1320 WOOD AVE – FRONT ENTRY COVERED PORCH Historic Preservation Board - January 6, 2025

Staff Report by Case Planner: Johnny Malpica

HIST-24-0015

Report of Acceptability

③ PERSPECTIVE - PROPOSED ENTRY

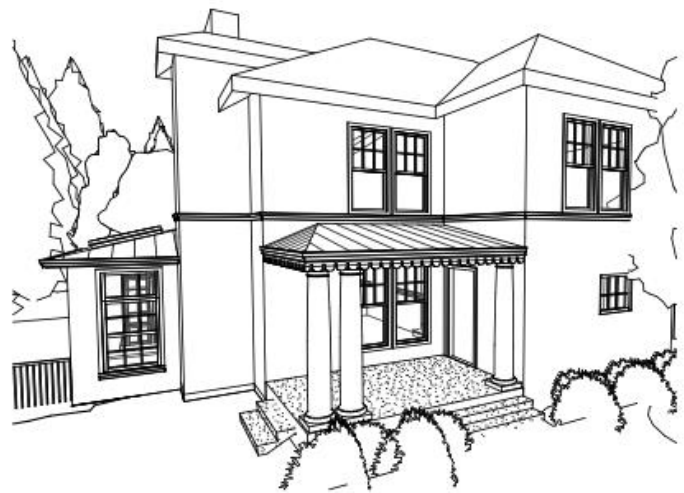
The proposal consists of the complete replacement of the concrete patio area and steps with a new raised concrete patio area and steps, as well as the removal and replacement of the awning with a larger copper hipped roof and scalloped fascia, supported by Tuscan style columns that together form a new covered porch to serve as the entry way for the primary residence. The concrete patio area is being raised to provide grade level access to the door of the primary residence, as currently, there is an additional step at the foot of the door. The new concrete patio area and steps will be the same red color to match the existing front walkway. The newly proposed hipped roof with a corresponding height and pitch to that of the primary structure's roof will consist of copper material that will naturally patina with age. The roof line will be adorned by a scalloped fascia and will be supported by three Tuscan style columns that match both the scale and style to the home's existing porte cochere and verandah. Overall, the proposal will create a more prominent front-facing façade that demonstrates attention to the building's Mediterranean architectural style, while seamlessly

balancing and further enhancing the frontispiece of the building. As such, the proposal further enhances the building's historic architectural significance.
